Origination Form
Proposed Revisions to a Standard Plans Index

Originator:	Turley, Joshua	Index Number:	700-091
Date:	4/23/2025	Sheet Number(s):	Sheet 2
E-mail:	Joshua.Turley@dot.state.fl.us	Index Title:	CATWALK DETAILS

GENERAL ASSEMBLY AND FIXED BASE DETAILS

SIDE ELEVATION

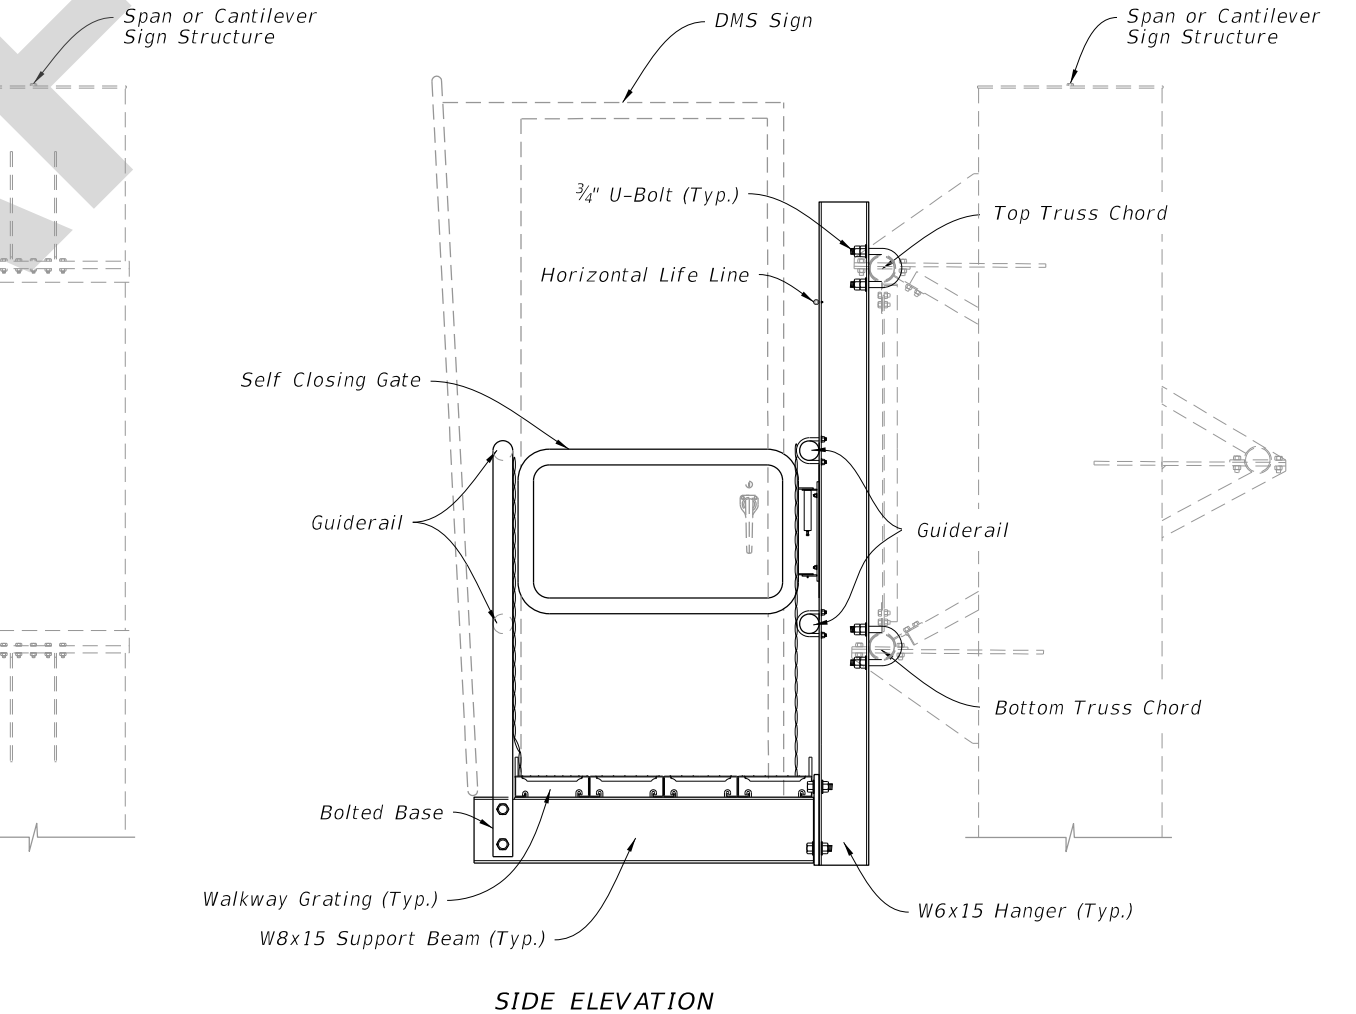
Sheet 2: Changed the weld size for the tube to tube connections of the guardrail.

The original weld size was overly conservative and not cost-effective. After analysis, the Structures Office specified a more appropriate weld for this index.
